## LEGAL NOTICE EXETER PLANNING BOARD AGENDA

**Date:** February 6, 2020  
**To:** Planning Board  
**From:** Dave Sharples, Town Planner  
**Re:** PB Case #19-13 I. S. Realty Trust

SUBDIVISION PLAN  
AT  
100 LINDEN STREET  
IN  
EXETER, NH  
FEBRUARY 2020

SCALE: AS NOTED    DESG. BY: C.M.Y.    PROJECT: E182237  
 DATE: AUG. 1, 2019    CHKD. BY: E.W.B.    SHEET: 4 OF 10

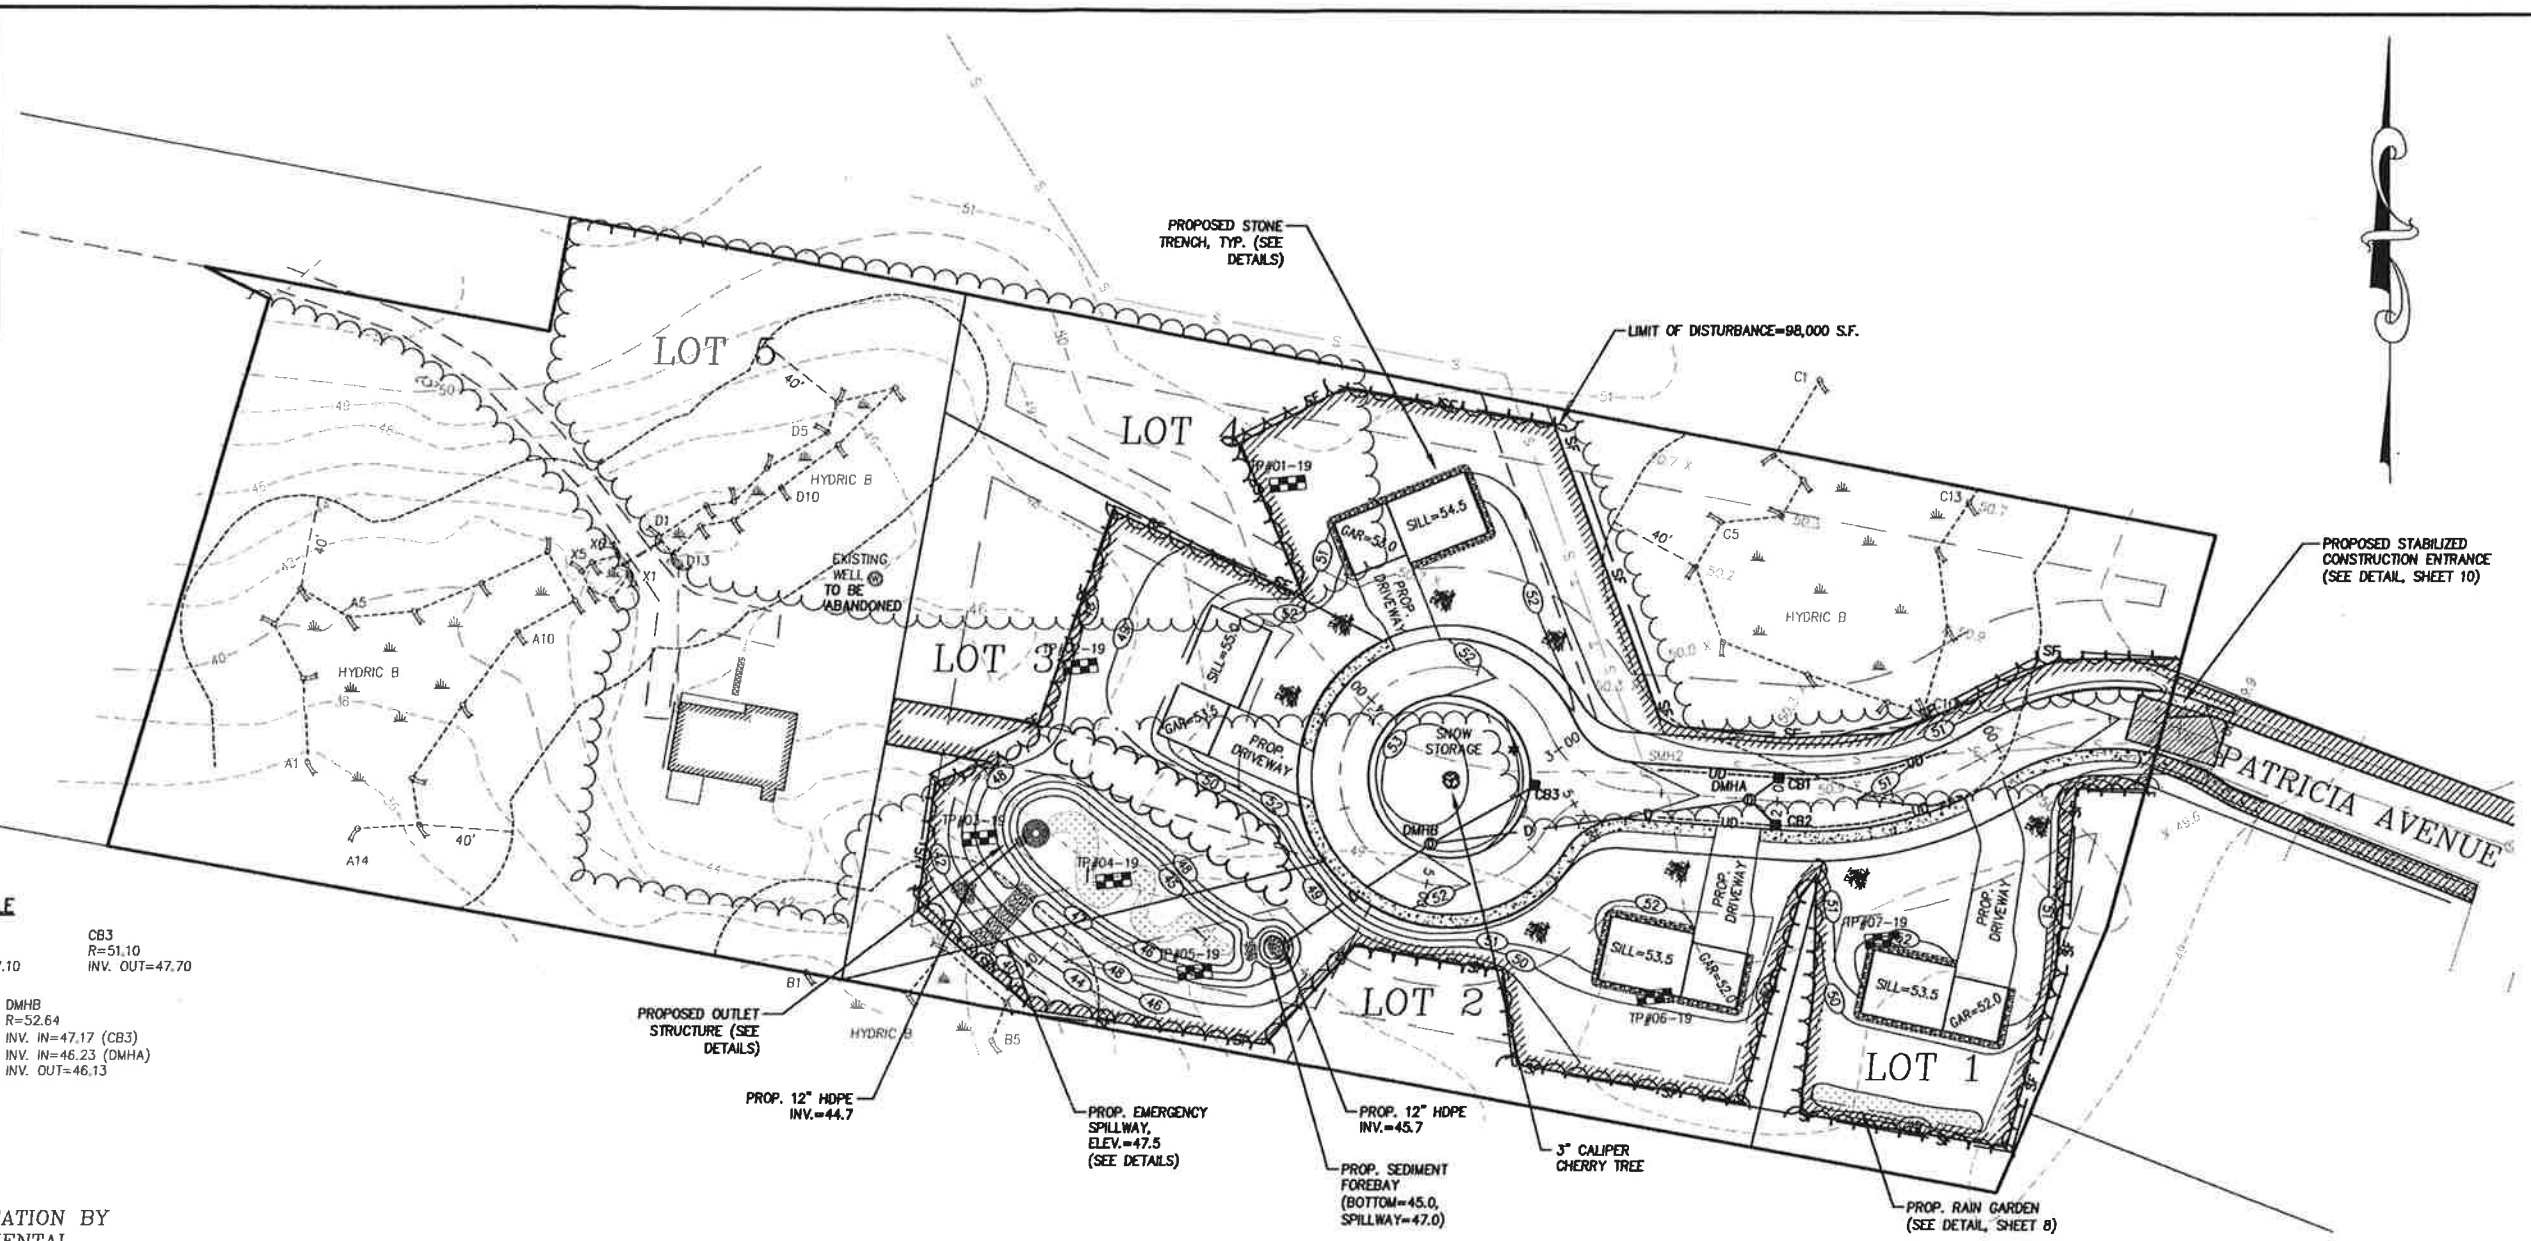
**27. Roadway Cross-Section STA. 0+00 to STA 2+75 (Sheet 4):** *The water and sewer mains locations shown on the cross-section do not match the stationing identified and should be noted as such. Underdrain locations should be shown on this cross-section as well.*

Response: The roadway cross-section has been updated accordingly.

SHEET: 6 OF 10

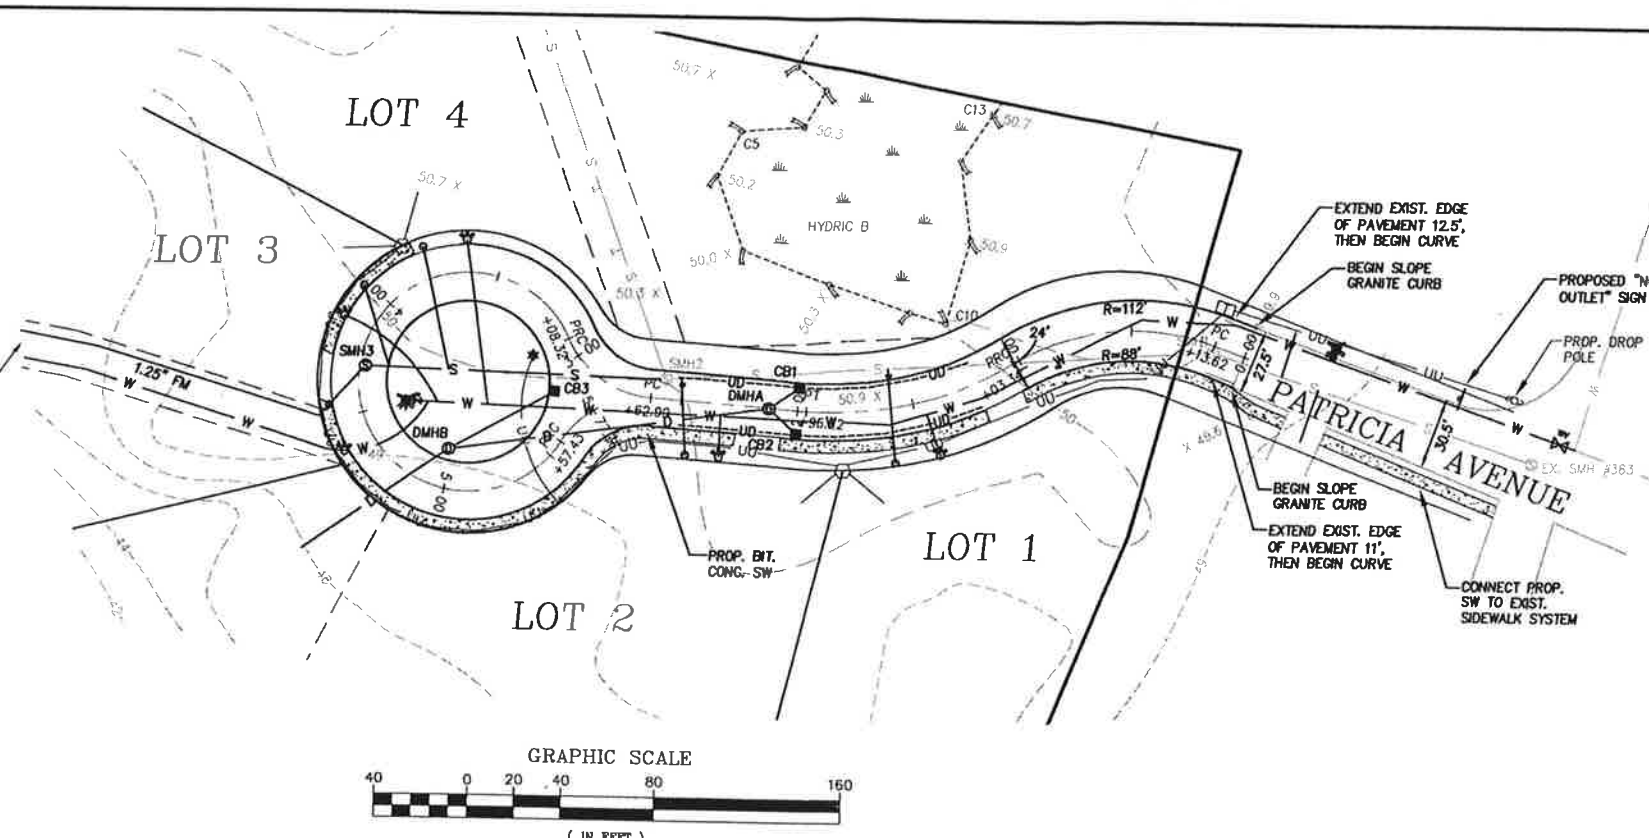
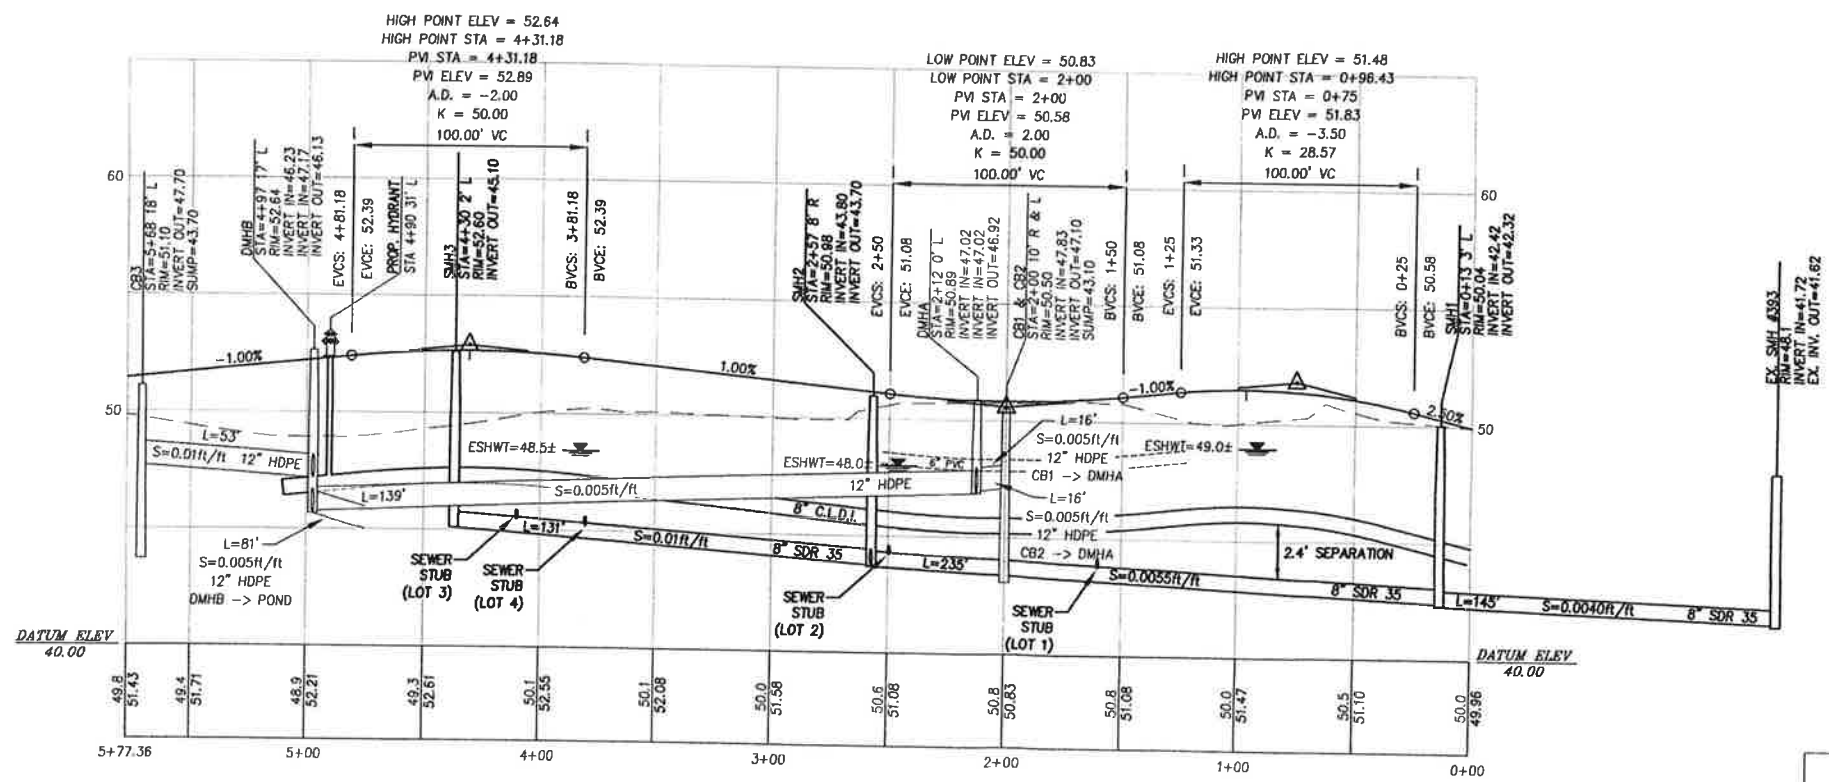
**23. Lot 5 Services (Sheet 6):** *The services for Lot 5 should be defined (i.e. size, material, and elevations).*

**24. Drain and Water Conflict (Sheet 6):** *The water and drain appear to be in conflict at STA 5+50. A crossing detail should be provided. Insulation should also be provided between the drain line and water main at the crossing to protect the water main from freezing temperatures.*

**25. Sewer and Catch Basin Conflict (Sheet 6):** *The proposed Catch Basin 3 and sewer main are in conflict. One of the utilities should be realigned. Insulation should be installed between the sewer and CB due their close proximity and a detail should also be provided.*

**26. Underdrain Inverts (Sheet 6):** *The inverts to the underdrains into CB1 and CB2 should be identified.*

**27. Sewer Cleanout (Sheet 6):** *The sewer service to Lot 5 should have a cleanout at the edge of the right of way. If the cleanout is installed within the sidewalk, a cast iron cover will be required.*

Response: The water service to Lot 5 will be the same as the services to the other lots (refer to detail on sheet 9). A sewer pump will need to be installed in the existing dwelling on Lot 5 (E-One or equivalent) with a 1.25" forcemain.

Response: I don't see an issue in this area. The water main crosses under the drain line coming out of CB3 but the top of the water main is about 18 inches below the drainpipe, a similar situation to where it crosses under the drain line coming out of CB2 and DMHA.

Response: The utilities have been updated accordingly. CB3 is now located at least 5 feet away from both water and sewer mains.

Response: The underdrain inverts have been added to the profile.

Response: The cleanout has been added to the plan.

**DETENTION BASIN  
PROFILE VIEW**  
HORIZ. SCALE: N.T.S.  
VERT. SCALE: 1"=2'

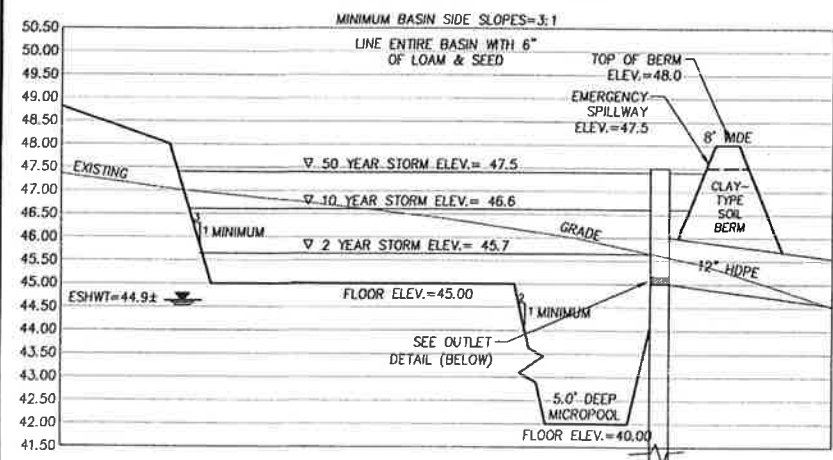
6. **Detention Pond:** *The following comments pertain to the Detention Pond shown on the Grading Plan:*
  - **ESHWT:** *The estimated seasonal highwater table (El. = 44.5') is above the base elevation of the detention pond (El. = 44.0'). The detention pond should have no standing water between storms with the exception of the micropool. The base elevation should be raised higher than the ESHWT.*

*UE 1/24/20 Comment: Based on the test pit information on Sheet 10 of the Plan Set, the permanent pool elevation within the Detention Pond may actually be higher than the 44.5' elevation shown on the Drainage Details on Sheet 7. Standing water may still occur above of the micropool elevation between storm events and continually drain offsite. The floor of the detention pond should be higher than the ESHWT elevation of 44.9' at TP#4.*

**18. Detention Basin Profile View and Outlet Structure Detail:** *The following comments pertain to the Detention Basin Detail and the Outlet Structure Detail:*

- See Comment 6 above.
- The outlet structure detail should be shown to scale or at least visually consistent with the profile view.
- Construction notes should be added detailing how the Micropool and Outlet structure will be constructed and whether any slope stabilization (e.g. riprap, TRM, wetland plants, etc.) will be used below the water surface.
- Buoyancy/stabilization calculations for the Outlet Structure should be provided during the shop drawing review process. A large portion of the outlet structure will be exposed on the micropool side. The buoyancy/stabilization calcs should also demonstrate that the structure will withstand potential unbalanced soil loads during low ground water periods.

Response: The pond design has been revised accordingly. The bottom of the basin is now at elevation 45.0.

Response: The outlet structure detail has been updated. A list of plants has been added to the detail for planting in the micropool. We are agreeable to buoyancy calculations during the shop drawing process.

PRECAST SEWER  
MANHOLE DETAIL

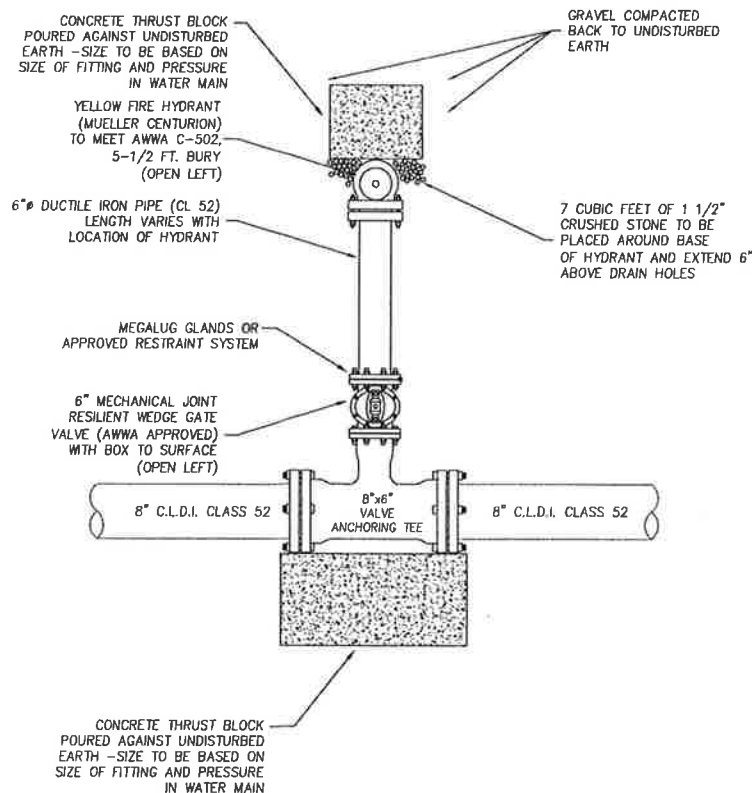
**28. Precast Sewer Manhole (Sheet 9):** *The Applicant has provided a sewer manhole detail with an external drop inlet. However, no drop inlet is proposed for this site. The SMH detail should be revised to reflect the proposed plans.*

**35. Flexible Boot Coupling:** *The existing SMH 2 is shown to be cored for the new SMH 3 connection. The SMH detail should note that a flexible boot coupling (e.g. Kor-N-Seal), per Town Standards, is required for all SMHs.*

Response: The detail has been revised accordingly.

Response: The detail has been revised accordingly (see note 6).
